Access Compliance Report Public Rights-of-Way (Curb Ramps)

Main Street: MEADOWOOD Cross Street: CASTLETREE Location: SE

ADA ID: RPRK211018150926 Ramp Type: Type 1 - Perpendicular Diagonal Initial Pass/Fail: Fail Overall Compliance: No Severity Score: 30

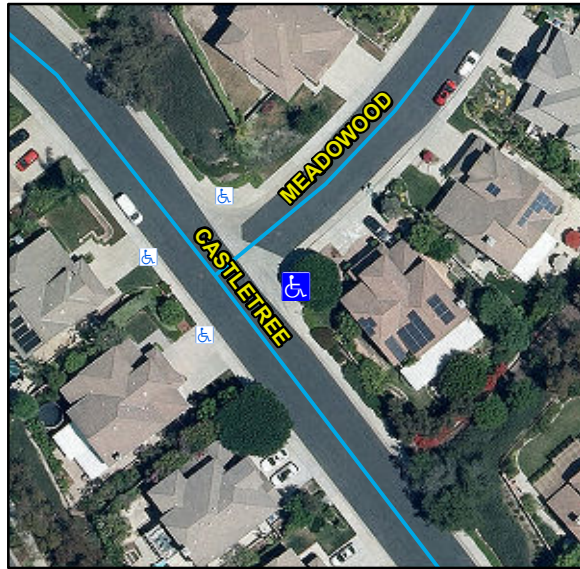
R304.2.2, R204.3, R304.5.3, R302.7.2, STD 1115

Remove & Replace Curb Ramp With Two New Directional Ramps or Equivalent.
